Road Safety Audit Stage 1
Proposed Access Arrangements
Wimblehurst Road
Horsham
West Sussex

Date: 13th February 2025

Project Title Horsham Enterprise Park, Wimblehurst Road, Horsham

Report Title Road Safety Audit Stage 1

Appendix B..... Comment Location Drawing

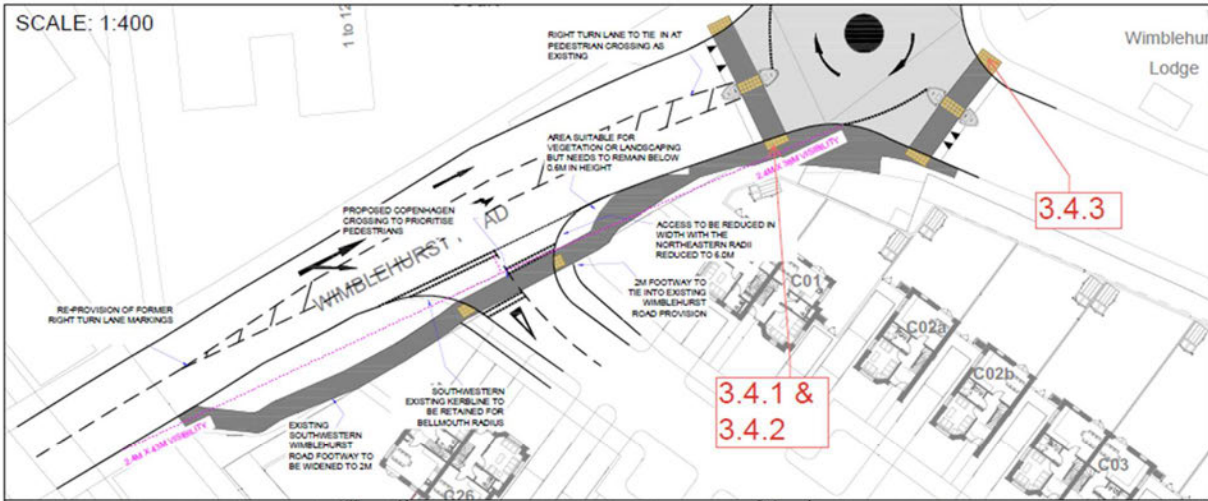
Location: Proposed pedestrian crossing point on the Wimblehurst Road arm of the roundabout, southeastern side of the carriageway.

Summary: Restricted visibility could lead to vehicle to pedestrian collisions.

No details relating to the pedestrian / traffic intervisibility splays at the crossing have been provided for assessment. There is concern that the hedgerow on the southwestern side of the Parsonage Road may restrict intervisibility, see figure 1 below. Restricted intervisibility could lead to vehicle to pedestrian collisions.

Location: Proposed pedestrian crossing point on the Wimblehurst Road arm of the roundabout.

Summary: Insufficient carriageway drainage could increase the risk of vehicle to pedestrian collisions.

On the southeastern side of the carriageway of Wimblehurst Road there was evidence of ponding and detritus at the crossing point, see figure 2 below. To the northeast of the crossing point it was noted that the gully was blocked, see figure 3 below, which could lead to the ponding. There is concern that this detritus could be a slip hazard for pedestrians. Further, pedestrians may find a less safe place to cross, which could lead to vehicle to pedestrian collisions, particularly for visually and mobility impaired pedestrians.

Location: Proposed pedestrian crossing point on the Parsonage Road arm of the roundabout.

Summary: Restricted visibility could increase the risk of vehicle to pedestrian collisions.

The pedestrian / traffic intervisibility splay to the north is obstructed by a wall, see figure 4 overleaf. However, it is recognised that this is an existing situation where a search on www.crashmap.co.uk

RSA Problem	RSA Recommendation	Design Organisation response)	Overseeing Organisation response	Agreed RSA action
<p>3.4.1 Location: Proposed pedestrian crossing point on the Wimblehurst Road arm of the roundabout, southeastern side of the carriageway.</p> <p>Summary: Restricted visibility could lead to vehicle to pedestrian collisions.</p> <p>No details relating to the pedestrian / traffic intervisibility splays at the crossing have been provided for assessment. There is concern that the hedgerow on the southwestern side of the Parsonage Road may restrict intervisibility, see figure 1 below. Restricted intervisibility could lead to</p>	<p>It is recommended that the hedgerow be cut back and periodically maintained to retain visibility.</p>	<p>Noted and agreed. Any existing vegetation (within the highway or client's ownership) will be cleared and periodically maintained to ensure visibility splays remain clear.</p>	<p>The Design Organisations comments are noted and agreed.</p>	<p>Existing vegetation within the highway and/or land within the control of the Applicant is to be maintained to ensure unobstructed visibility splays.</p>

<p>vehicle to pedestrian collisions.</p>				
<p>3.4.2 Location: Proposed pedestrian crossing point on the Wimblehurst Road arm of the roundabout.</p> <p>Summary: Insufficient carriageway drainage could increase the risk of vehicle to pedestrian collisions.</p> <p>On the southeastern side of the carriageway of Wimblehurst Road there was evidence of ponding and detritus at the crossing point, see figure 2 below. To the northeast of the crossing point it was noted that the gully was blocked, see figure 3 below, which could lead to the ponding. There is concern that this detritus could be a slip hazard for pedestrians. Further, pedestrians may find a less safe place to cross, which could lead to vehicle to pedestrian collisions, particularly for visually and mobility impaired pedestrians.</p>	<p>It is recommended that the gully be cleared, and the detritus removed.</p>	<p>Noted and agreed. Gullies will be cleared and periodically maintained to prevent ponding and ensure there are no drainage issues. The roundabout is no longer proposed to be raised which should address these concerns, but the development will pay contributions towards the delivery of tactile paving and dropped kerbs that are currently lacking on the Parsonage Road and Wimblehurst Road arms – thus improving the routes for pedestrians and visually/mobility impaired users.</p>	<p>Those works previously proposed by the Applicant at the existing North Heath Lane, Parsonage Road, Wimblehurst Road mini-roundabout are no longer included. Given this, there is no requirement for the Applicant to undertake what is effectively routine maintenance that should be completed by the County Council in its role as Local Highway Authority.</p> <p>As noted, the Applicant is funding schemes of crossing improvements (which includes at the existing mini-roundabout). Any gully maintenance can be undertaken by WSCC as part of these.</p>	<p>No further action is required.</p>

<p>3.4.3 Location: Proposed pedestrian crossing point on the Parsonage Road arm of the roundabout.</p> <p>Summary: Restricted visibility could increase the risk of vehicle to pedestrian collisions.</p> <p>The pedestrian / traffic intervisibility splay to the north is obstructed by a wall, see figure 4 overleaf. However, it is recognised that this is an existing situation where a search on www.crashmap.co.uk revealed that there had been no pedestrian related collisions at this junction in the period 2019 to 2023. Restricted visibility could increase the risk of vehicle to pedestrian / cyclist collisions.</p>	<p>It is recommended that vegetation should be cut back and periodically maintained to retain visibility. Further, that the impacted splay where the wall exists should be monitored at Stage 4 Audit and if a related collision problem exists than remedial measures should be investigated.</p>	<p>Noted. The vegetation falls within land ownership of Wimblehurst Lodge. Encroachment of vegetation into highway land will be monitored periodically and maintained when required in line with Section 154 of the Highways Act 1980.</p> <p>Should the Stage 4 audit flag any concerns, these can be further reviewed.</p>	<p>It is noted that the overhanging vegetation falls within land under the control of the Applicant. The vegetation can be cut back as needed.</p> <p>It should be noted that under the current WSCC Road Safety Audit Policy, this proposal will not trigger a requirement for a Stage 4 RSA. A Stage 3 RSA is expected to be required and triggered once the development is completed or as agreed with the Design team.</p>	<p>No further action required at this stage.</p> <p>Any vegetation overhanging the highway within the development is to be cut back as required.</p> <p>The Applicant should note the need for a Stage 3 RSA.</p>
